Polarisation mode dispersion values

IEEE P802.3ba, Dallas, November 2008

Introduction

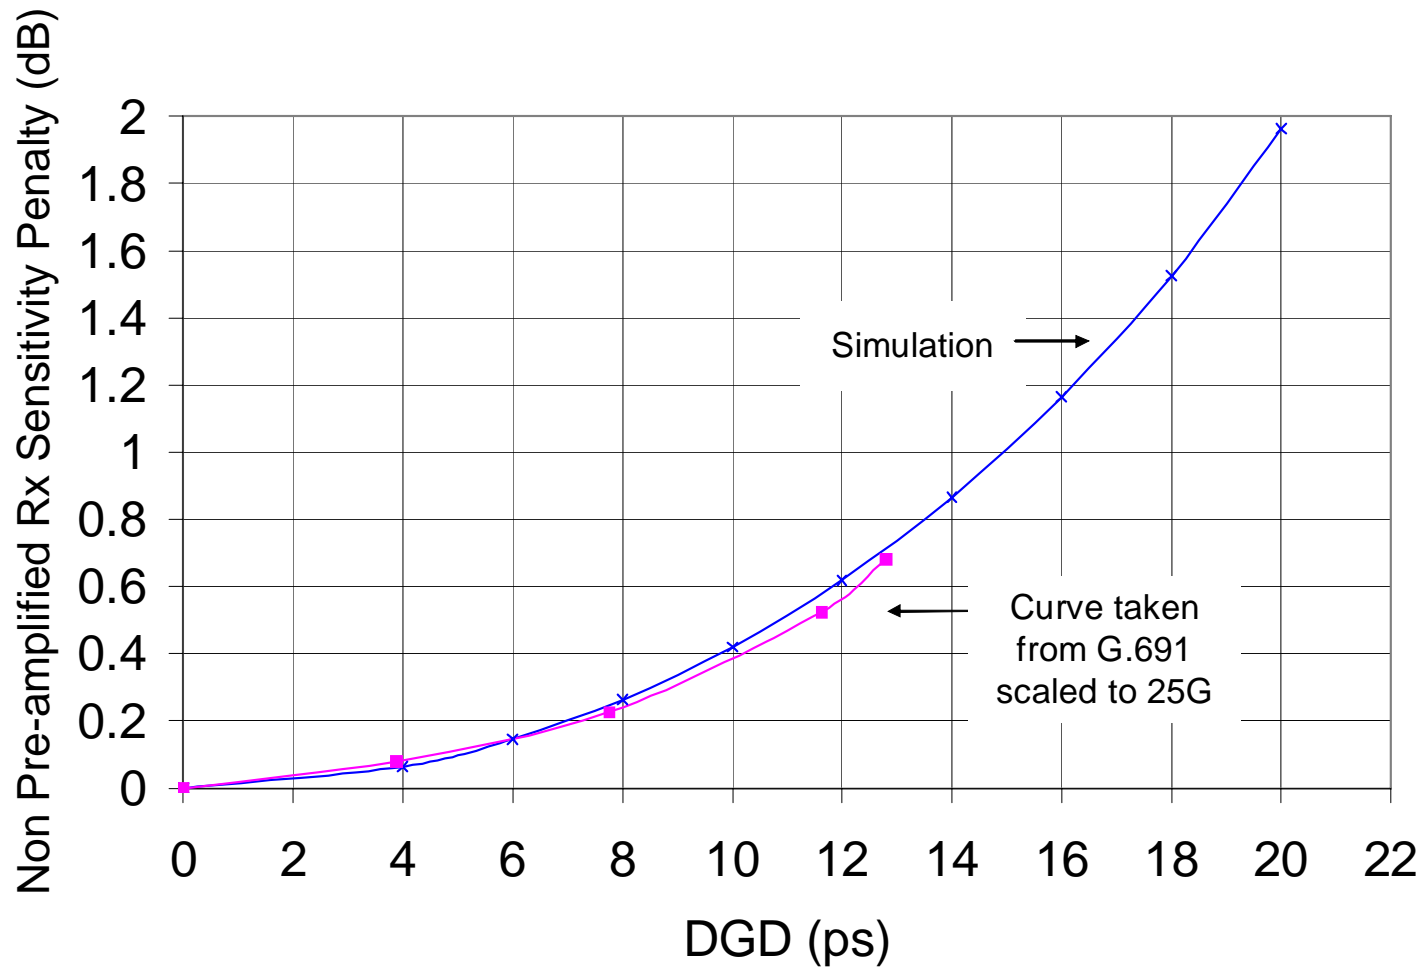
The DGD_max value for 10GBASE-LR in Table 52-24 is 10 ps with a max link length of 10 km.

This value came from the P802.3ae Equalization Ad Hoc [\[1\]](#) and equates to a link PMD coefficient of ~ 0.8 ps/sqrt(km) (assuming $S = 3.75$ or 2.6 sec/year above the “Max”).

This is expected to give only a small penalty at 10.3125 GBd (~ 0.1 dB). See [anslow_01_0308.pdf](#) slide 4.

Consequently, it is proposed to also set DGD_max to 10 ps for 40GBASE-LR4

25.8G PMD penalty for 100GBASE-LR4

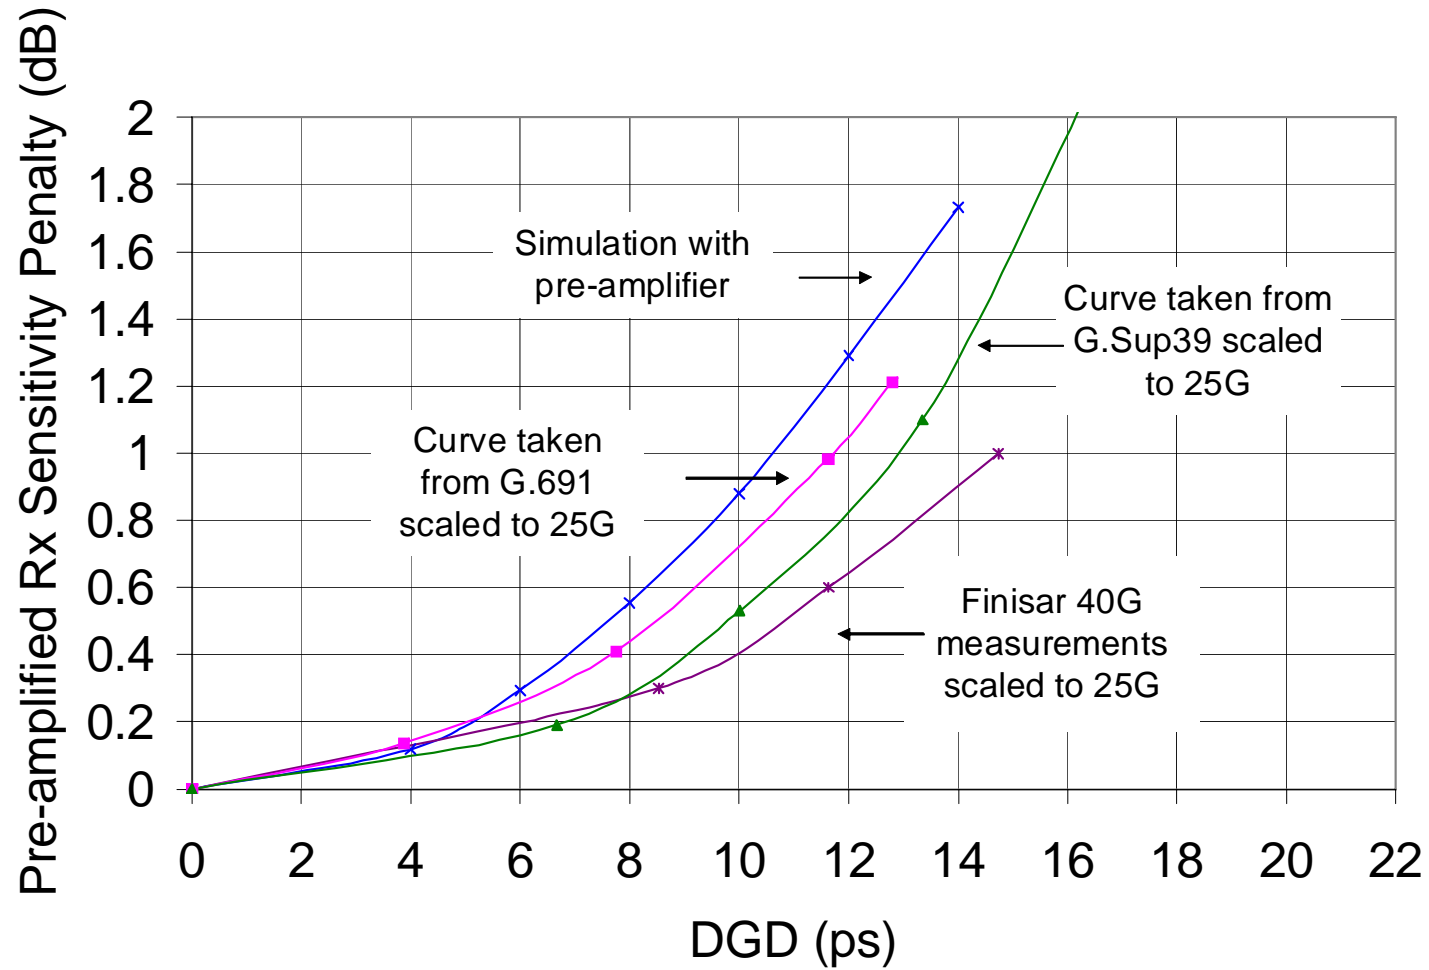
As can be seen from these curves, the predicted penalty for a DGD of 10 ps is ~0.4 dB.

This value seems acceptable within the provisional 2.2 dB allocation for penalties for 100GBASE-LR4

Consequently, it is proposed to also set DGD_max to 10 ps for 100GBASE-LR4
